**116a – 122b Epping Road, 259 – 263 Lane
Cove Road and 1 – 9 Allengrove
Crescent, North Ryde**

MP 10_0037 – Modification 1

**Modification of the building envelopes
and modification of the terms of approval
to obtain approval for 179 apartments
and 218 car parking spaces**

Director-General's
Environmental Assessment Report
Section 75W of the
Environmental Planning and Assessment Act 1979

Figure 2 – Proposed changes to building envelopes – Roof level

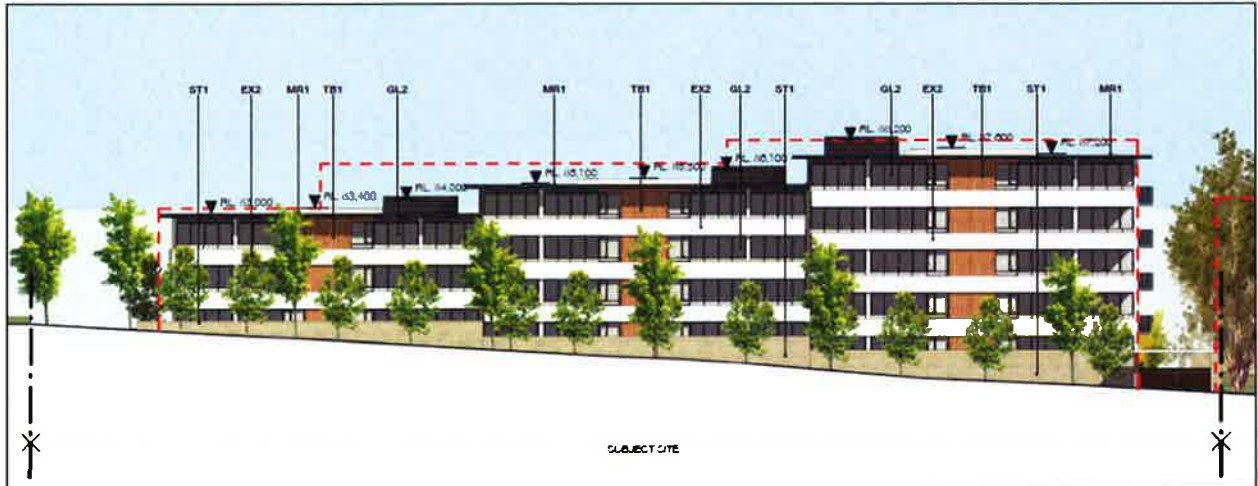
The proponent has provided an envelope study which details the proposed modifications to the building envelopes. **Figure 2** (below) shows the changes at the roof level which provide a general indication of the scope of change. **Figure 3** shows the eastern (Epping Road) elevation.

The deletion of the gap between the two centrally located building envelopes will create a longer single envelope (building C) (refer **Figure 2**). The building will maintain a similar relationship with the neighbouring properties as the additional bulk is centrally located within the site. The additional bulk will be visible from Allengrove Crescent (refer **Figure 5**) through the gap in building D, but this will have a minimal impact as it would be setback 35 metres from the street. Views of building C from Allengrove Crescent are obstructed by building D, further minimising its visual impact.

Figure 4 – Indicative setbacks to eastern portion of building D

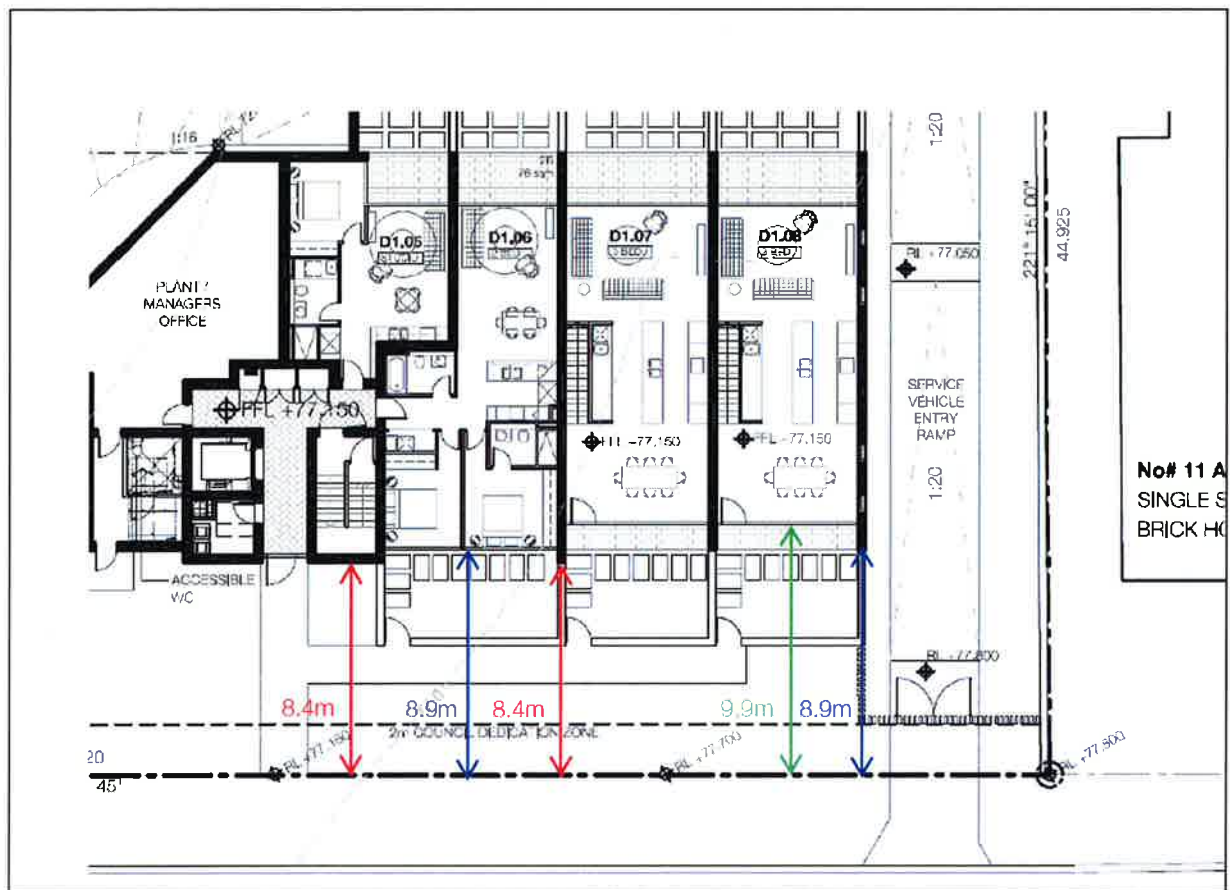
It is also proposed to reduce the setback of building D from Allengrove Crescent from 8.9m to 8.5m. On the indicative floor plans, the façade of the building is stepped with the fire stairs and framing elements setback 8.4m, whilst the majority of the façade is setback 8.9m as illustrated in Figure 4 below. The proposed reduction is supported on the basis that it is a minor change and the proposed envelope can achieve an acceptable relationship to the street.

Figure 5 – Western (Allengrove Crescent elevation)

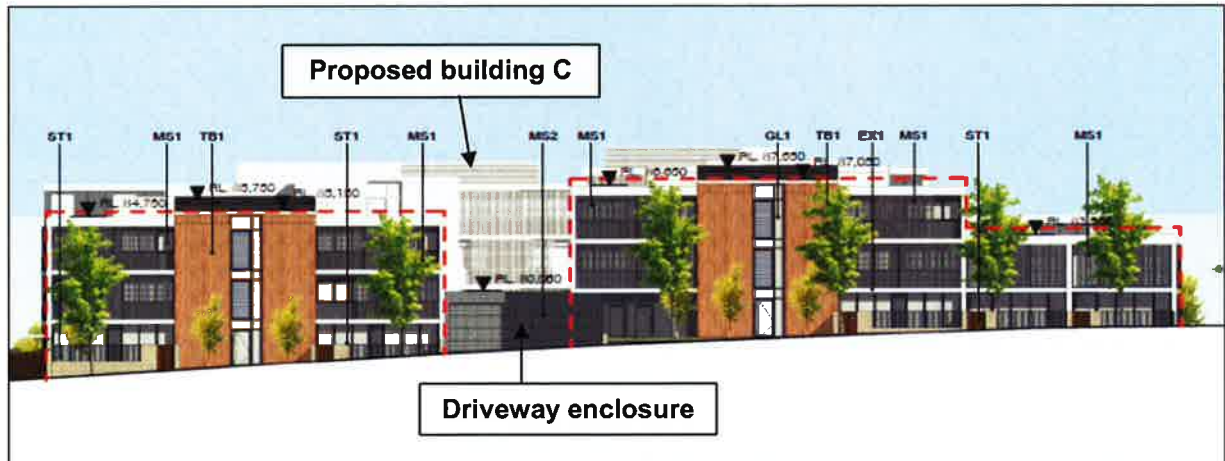
The proposed driveway enclosure would create a link between the two approved building D envelopes at Allengrove Crescent. The enclosure will not be visually prominent being a single building sitting between 2 three storey buildings (refer **Figure 5**). Its visual impact is further mitigated as it would have a greater setback from the street than the adjoining building.
